Pre-Hearing Ground Water Discharge Plan Analysis

MT. TAYLOR URANIUM MILL PROJECT
GULF MINERAL RESOURCES COMPANY

Ground Water Section
Water Pollution Control Bureau
New Mexico Environmental Improvement Division

September, 1980

FIGURE 14

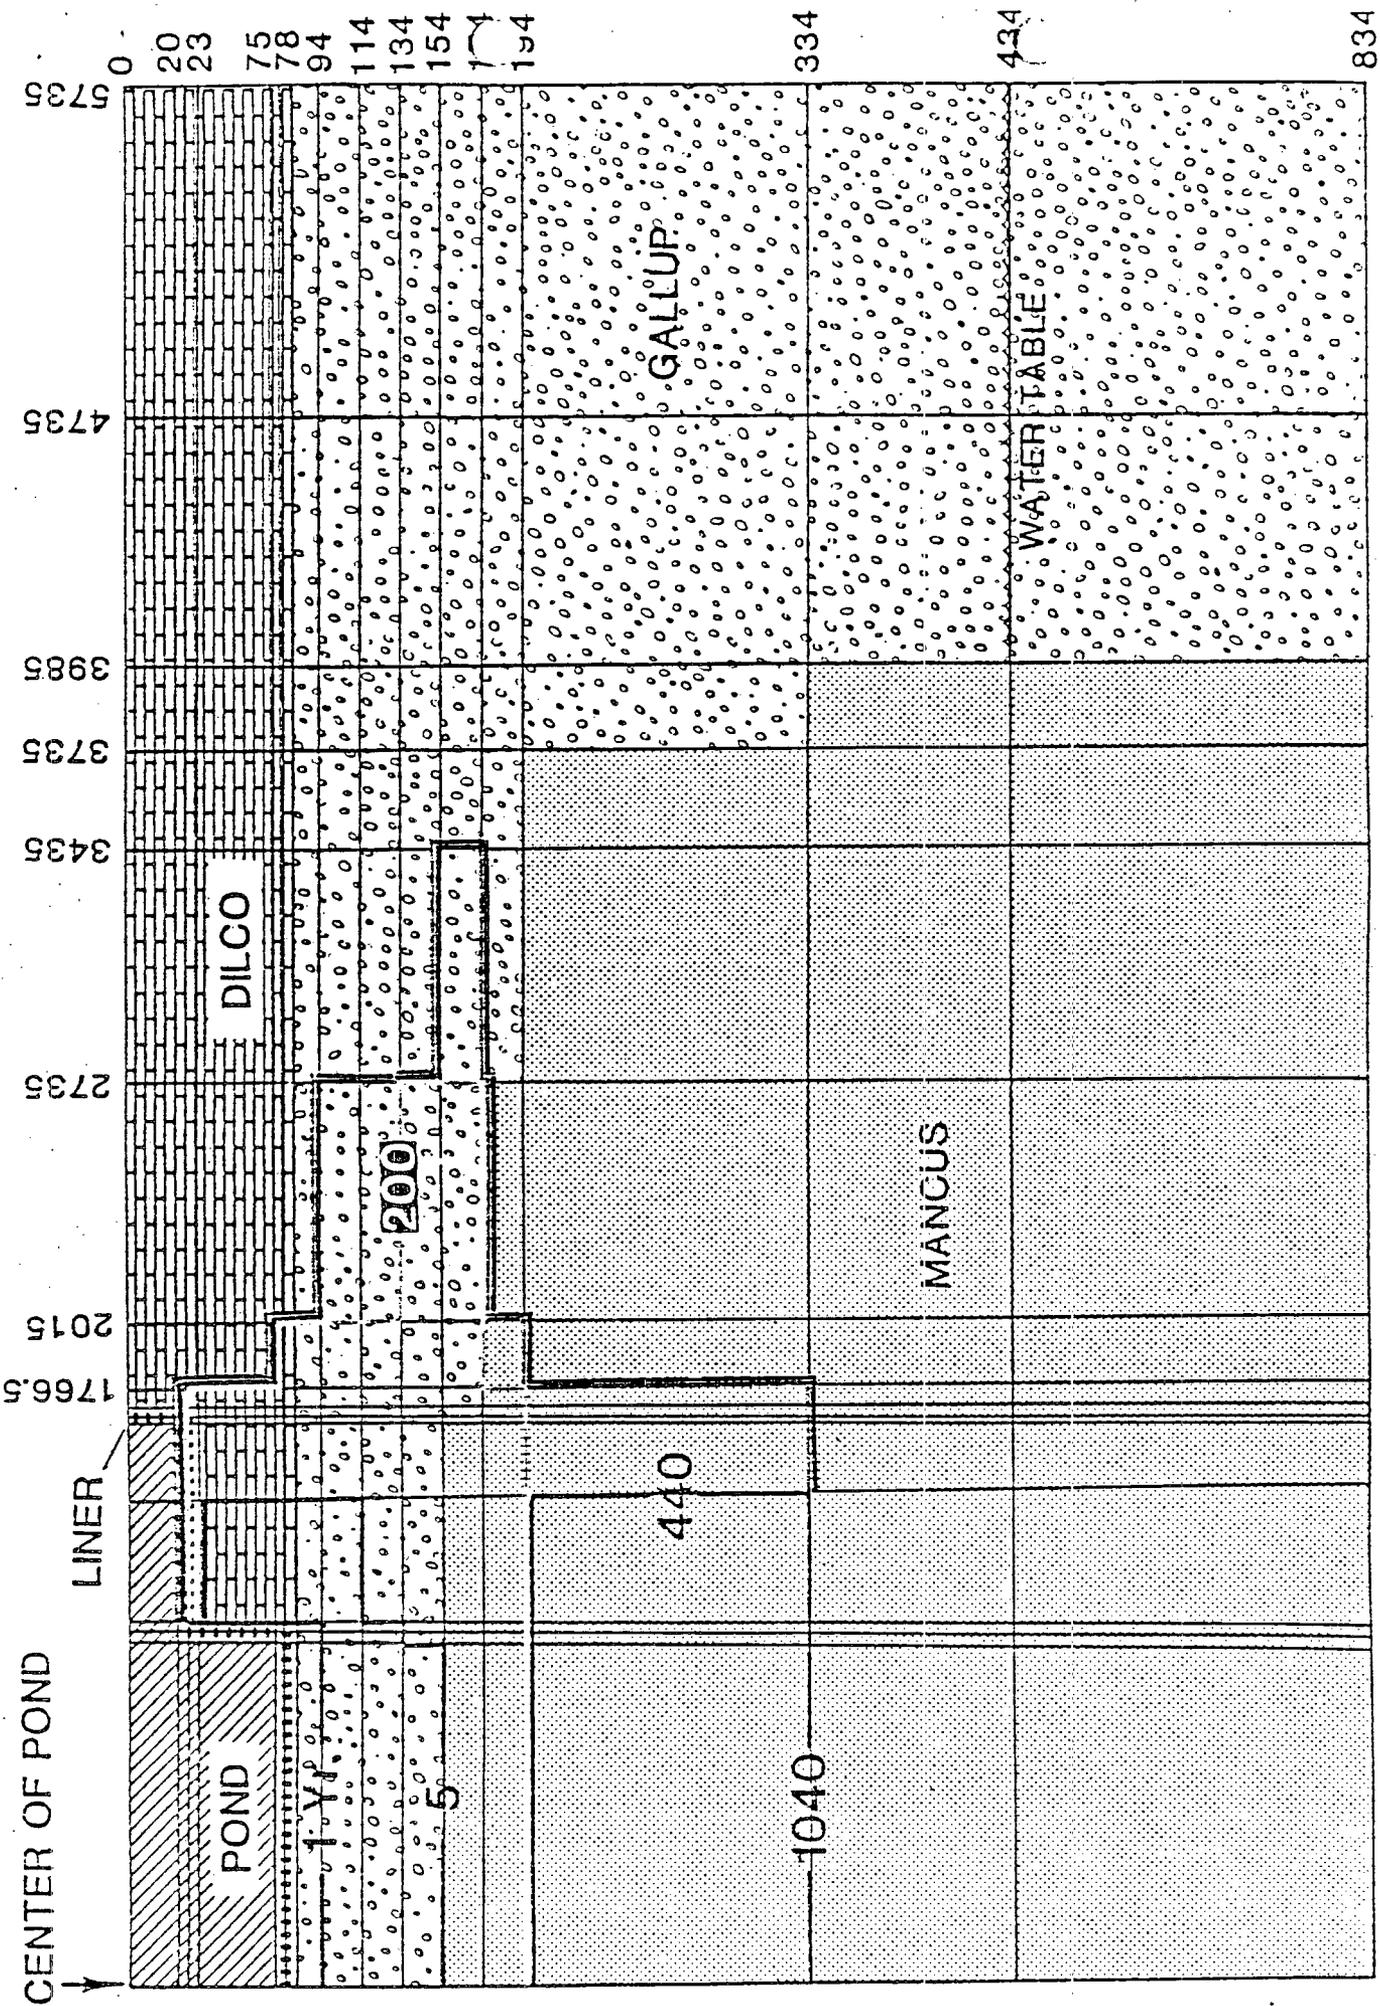
An additional computer simulation considered staff-suggested saturated and unsaturated hydraulic conductivity values. Table 3 shows the saturated hydraulic conductivities employed for this simulation. Adjustments in both horizontal and vertical hydraulic conductivities were made to consider probable vertical stratification in hydraulic conductivities and bedding plane induced anisotropy (horizontal hydraulic conductivity: vertical hydraulic conductivity = 20:1). Hydraulic conductivities of the liner were increased by a factor of 10. Figure 14 shows the results of the later simulation. The seepage front has not advanced as far as the front in the original work at a comparable time.

Based upon the information referenced above, the staff supports Gulf's conclusion that the seepage front will not invade the water table. This interpretation, of course, must be predicated upon proper quantification of the hydrologic properties of the site. Upon implementation of construction and monitoring activities, additional field data will become available for consideration. If site conditions are then found to be significantly different than present data suggests, the seepage projections should be revised.

FIGURE 15

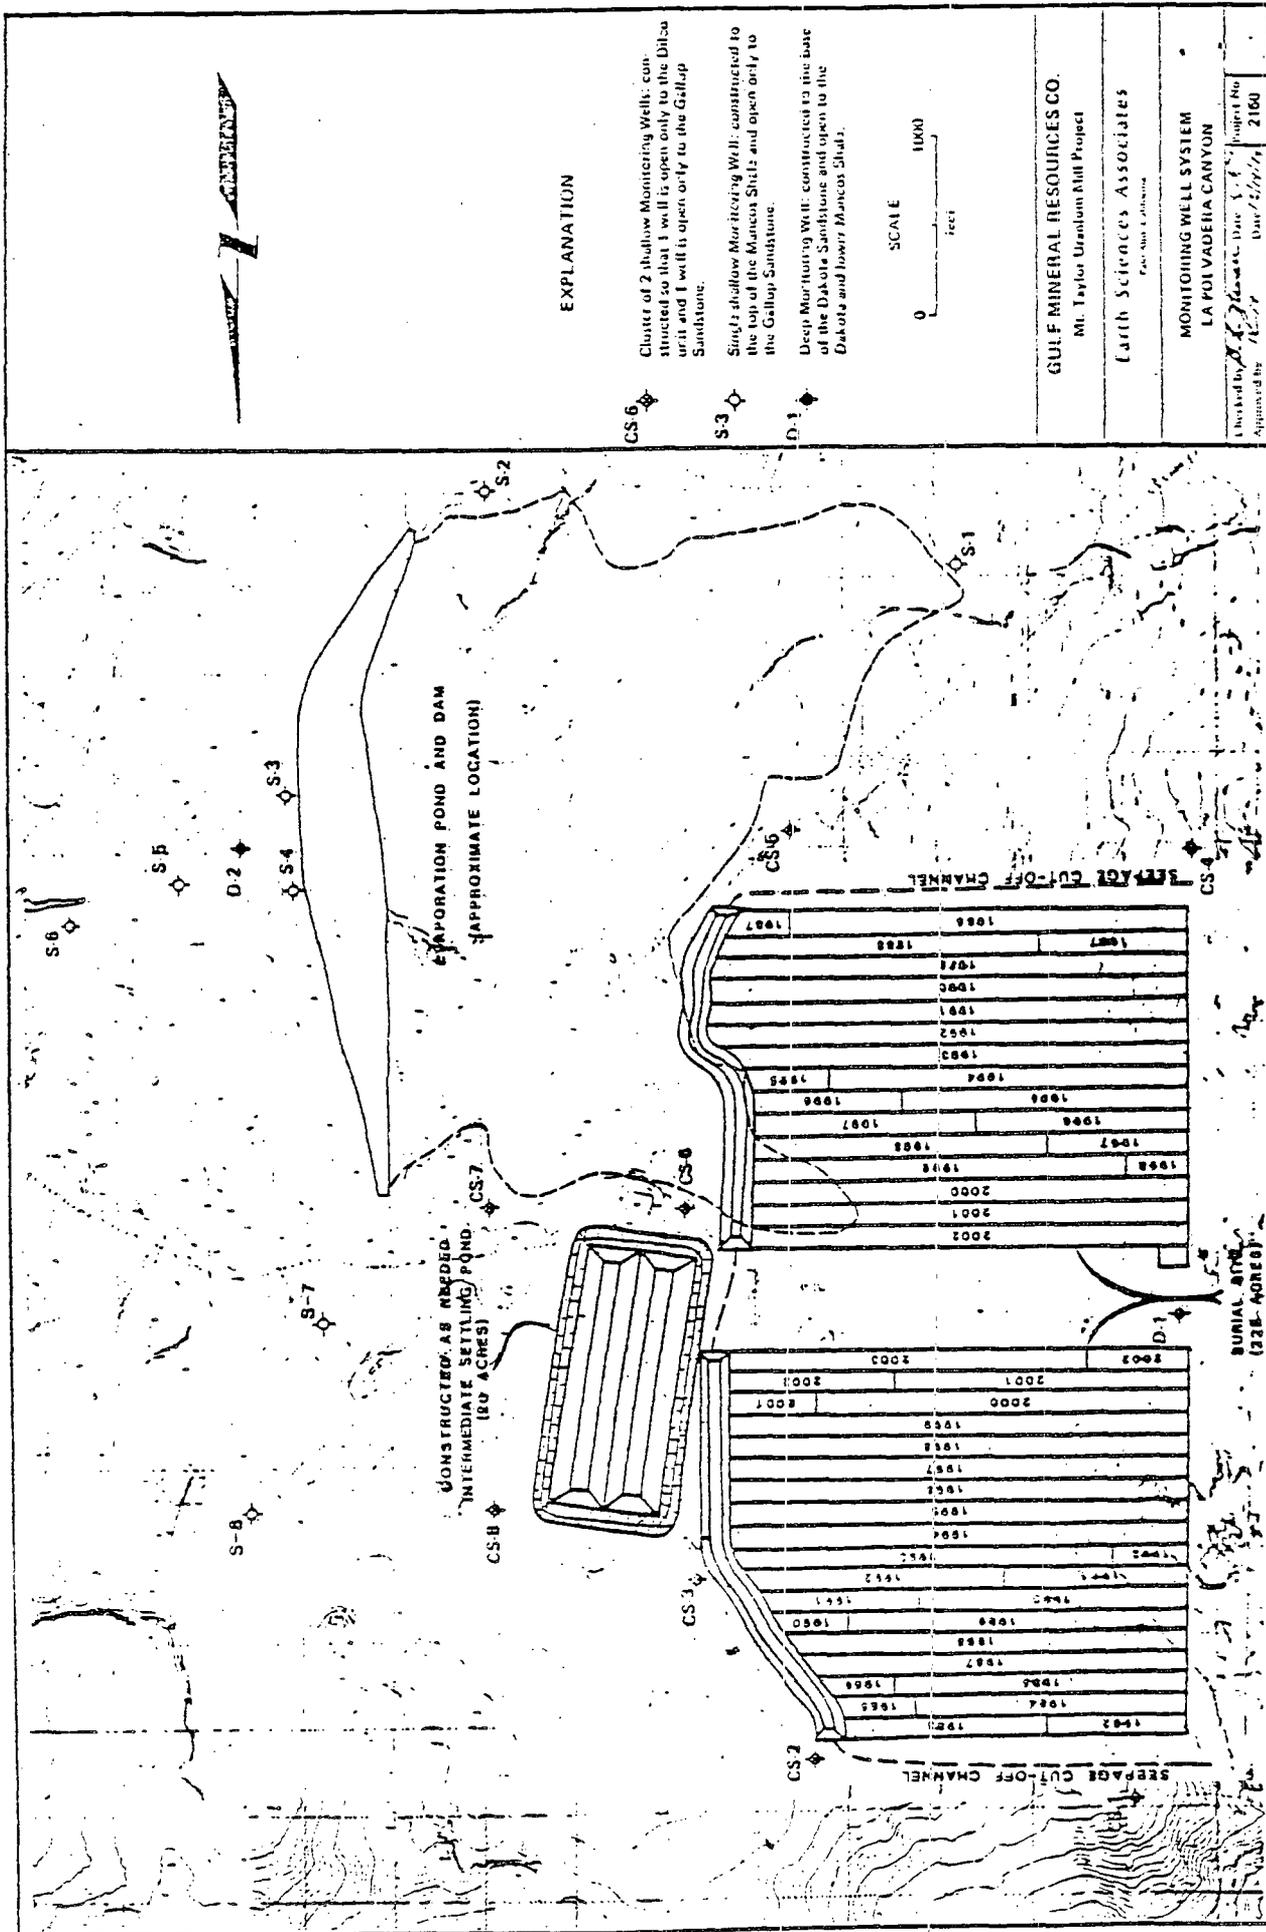
Given the uncertainties regarding rock conditions at the pond site, the staff does not feel that a final monitoring array can be established prior to pond-bottom exhumation. In general, the proposed shallow array shown in Figure 15 seems acceptable; it is considered prudent, however, to hold in abeyance recommendations regarding the monitoring configuration and design until this additional on-site data can be incorporated.

- (8) Prior to discharge of any waste products in La Polvadera Canyon, the discharger shall develop and submit for EID approval a revised monitoring system, and shall have received EID approval thereon. The information obtained from carrying out conditions (6) and (7) detailed above shall be used in developing the revised monitoring system.
- (9) The discharger shall on a quarterly basis, collect representative samples of the evaporation pond liquid and by measurement suitable to EID estimate the total volume of liquid in the pond. The liquid samples shall be analyzed for the standard constituents tabulated in section 3-103 of the regulations and for total suspended solids.
